**City of Richmond**  
Urban Development Division

## Report to Development Permit Panel

**To:** Development Permit Panel  
**From:** Raul Allueva  
Director of Development  
**Date:** February 1, 2005  
**File:** DP 04-280307  
**Re:** **Application by Patrick Cotter Architect Inc. for a Development Permit for a Portion of 7331 No. 4 Road (Formerly a Portion of 7351 No. 4 Road)**

1 UNIT TYPE 'C'  
ACCESSIBLE GROUND FLOOR PLAN  
SCALE 1/4"=1'-0"

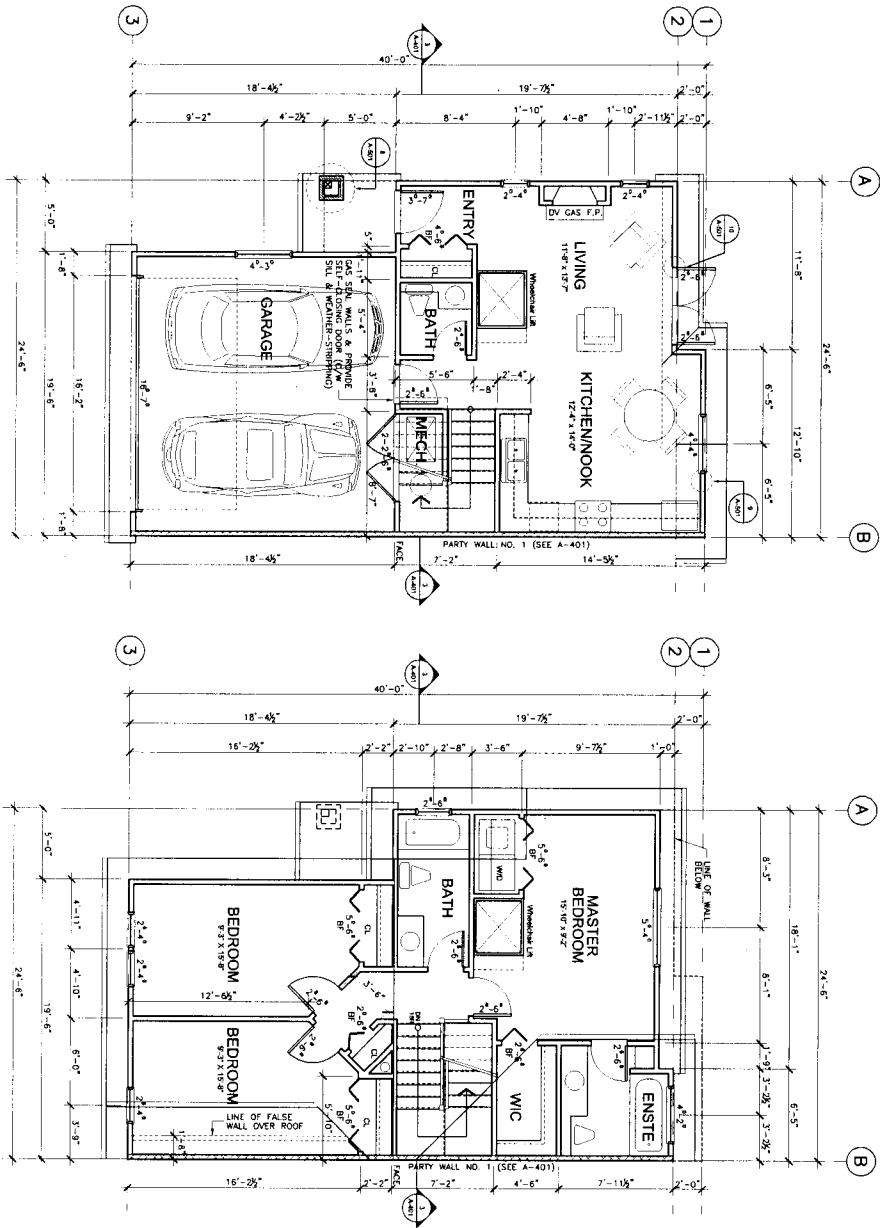
- Unit E could be easily adapted to an accessible unit - *An alternate floor plan has been provided demonstrating adaptability of unit C;*
- tandem parking could prove to be a safety issue - *The use of tandem parking is limited to two of the six units. Standard double-car garages will be provided for the remaining four units;* and
- a nice looking project. Intersections could be softened by the use of pavers. A median tree size was suggested - *Although pavers are not proposed for the manoeuvring aisle intersection, a variety of paving treatments is proposed, consistent with Phase I paving treatment, including pavers, texture and colour. Six of the fifteen new trees proposed are larger specimens of minimum 15 cm dbh .*

1. SITE PLAN (PHASE II ONLY)  
 SCALE: 1/8" = 1'-0"

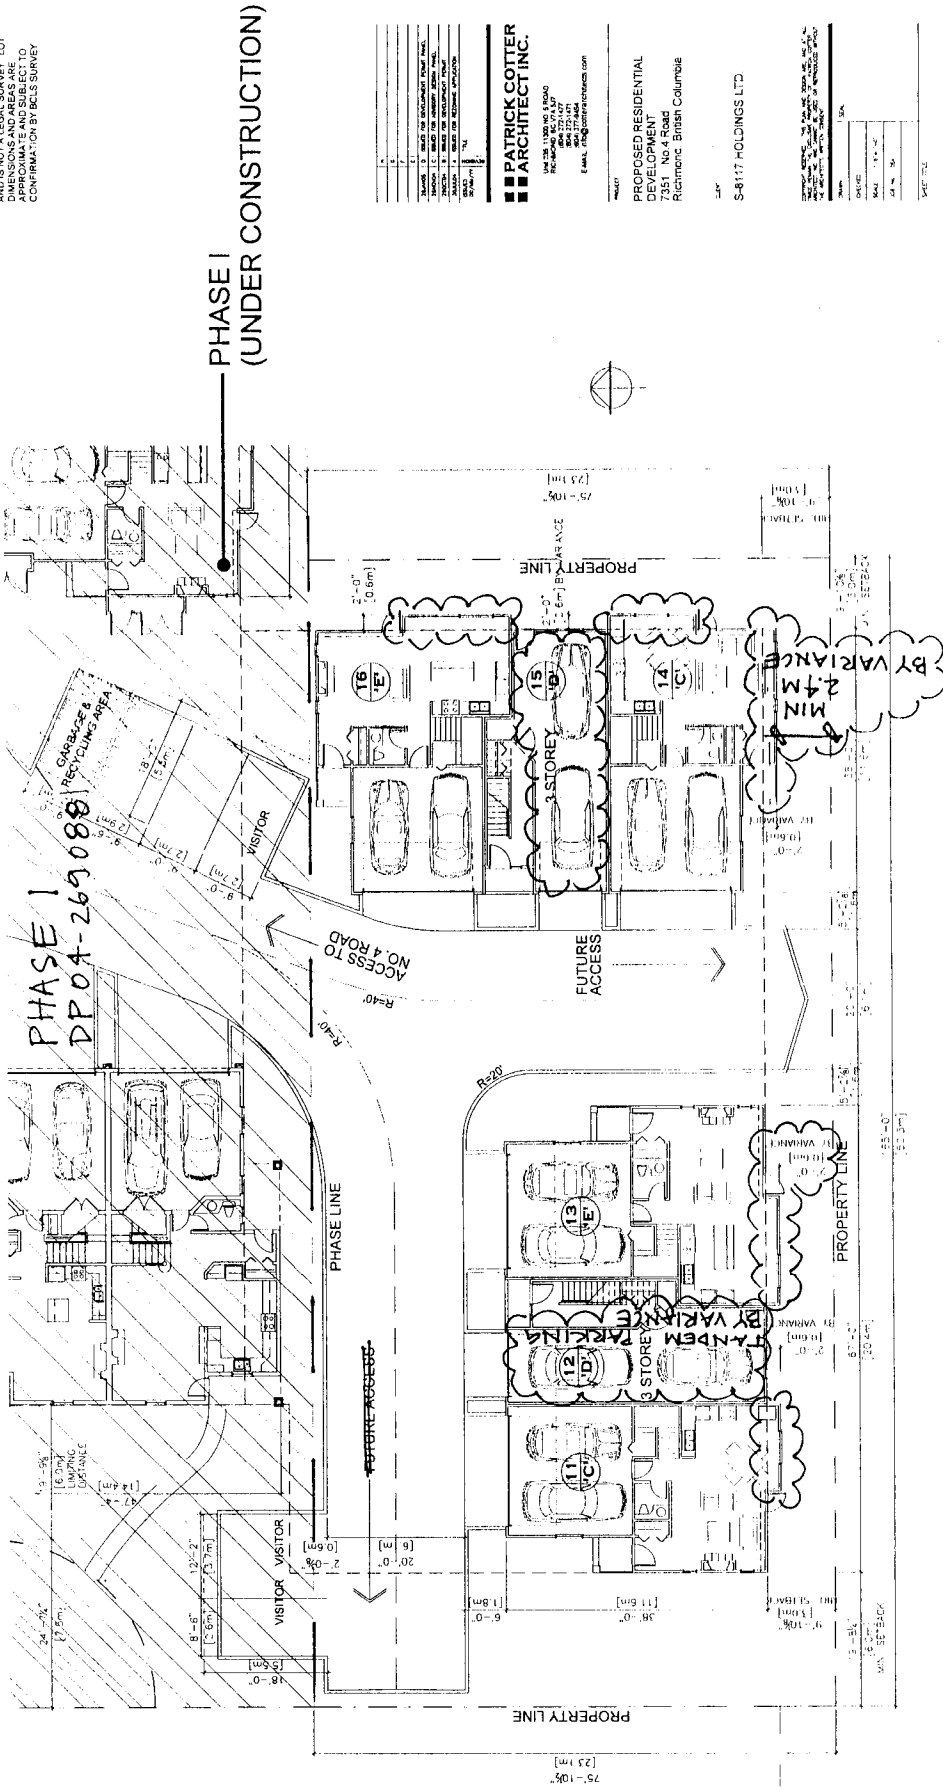
- 1) To vary the provision of Section 291.35.4 (Minimum Setbacks From Property Lines) to reduce the minimum required south side yard setback from 3 m to 2.4 m for the southeast unit.

- 2) To vary the provision of Section 291.35.4 (Minimum Setbacks From Property Lines) to permit projections into the south and east side yard setback of 0.6 m on four (4) units.

- 3) To vary the provision of Division 400 (Off-Street Parking & Loading) to permit four (4) tandem parking spaces.

*(Staff supports the proposed variance as the variance only applies to a portion of the side elevation of the building, the building face is articulated, a variety of roof forms are provided and the setback increases as the building height increases. In addition, landscaping measures have been taken to reduce the impact of the development on the adjacent existing single-family home back yard to the south in the form of new tree planting with larger specimens and 1.8 m privacy fencing).*

*(Staff supports the proposed variance as landscaping measures have been taken to reduce the impact of the development on the adjacent existing single-family home back yards to the south and west in the form of new tree planting with larger specimens and 1.8 m privacy fencing. The proposed 0.6 m single-storey building projections are limited to at grade with no upper storey encroachments. The encroachment into the side yard is consistent with the previously approved Development Permit for Phase I).*

*(Staff supports the proposed variance as it is consistent with other townhouse development in the City Centre and the mix of standard and tandem parking is appropriate. Standard side-by-side double car garages are proposed for four (4) of the six (6) units).*
